## **Technical Service Information**

## THM 440-T4 NEW 4TH CLUTCH STEEL PLATES

Figure 1

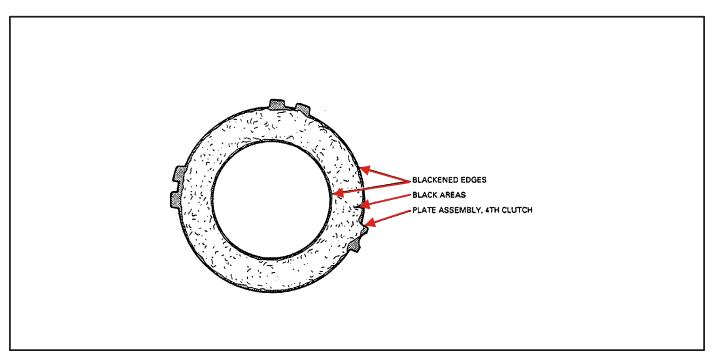
**CHANGE:** New 4th clutch steel plates with "Blackened" edges (See Figure 1).

**REASON:** The new plates are made with a new process, to aid manufacturing. The by-product of this

new process is that the edges will be blackened, and the clutch surfaces will have some lightly

blackened areas.

(1) 4TH CLUTCH STEEL PLATES - Will have "Blackened" edges and the clutch surfaces will have some lightly blackened areas (See Figure 1). Do not replace the steel plates merely for this condition, as it is normal.

The new "Blackened" 4th clutch steel plates will retro-fit back to ALL previous models. When the supply of previous steel plates is depleted,

the blackened plate will be the only one available through OEM sources.
